# Appendix A.2 RESPONSES TO COMMENTS TO ORIGINAL PEIR

# LIST OF PERSONS, ORGANIZATIONS, AND PUBLIC AGENCIES THAT COMMENTED ON THE DRAFT ENVIRONMENTAL IMPACT REPORT (EIR)

Subject: Comments on the Master Storm Water System Maintenance Program Draft Program Environmental Impact Report, Project Number 42891,

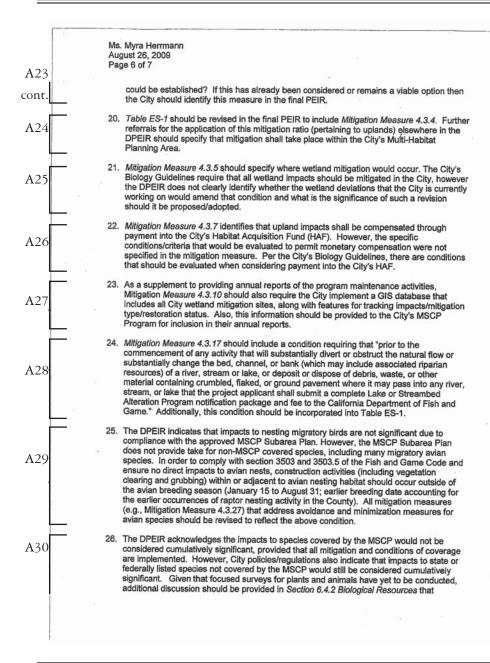
- 14. The DPEIR states that, "The compensation ratio proposed by the City would vary with the type of wetland habitat and the frequency of maintenance. Typically, state and federal agencies require creation at a ratio of 1:1 to achieve their "no net loss" policies......" The Department would emphasize that a 1:1 ratio may not be appropriate for purposes of this project (particularly when considering the high frequency maintenance component and the proposal to mitigate for those impacts at a 1:1 ratio). For example, it is probable that indirect impacts will continue with long-term maintenance and that this could adversely affect the ability of some areas to support listed species, particularly over time, and that with any further reduction in habitat quality, the populations of some of these species may be reduced to a level that is not self-supporting.

- 15. The DPEIR does not mention whether the forthcoming projects requiring Streambed notification would be processed on an individual permit basis or whether the City would qualify for processing a Master 1602 permit. If this information is available, then those details should be provided in the final PEIR.

- A.20. Refer to response to comment A.12 for a discussion of proposed modifications of ratios and the rationale for those ratios that do not match the City's MSCP and Biology Guidelines

- A.21. For the reasons stated in Response to Comment A.12, habitat creation is not a required component of the mitigation requirements specified in the PEIR.
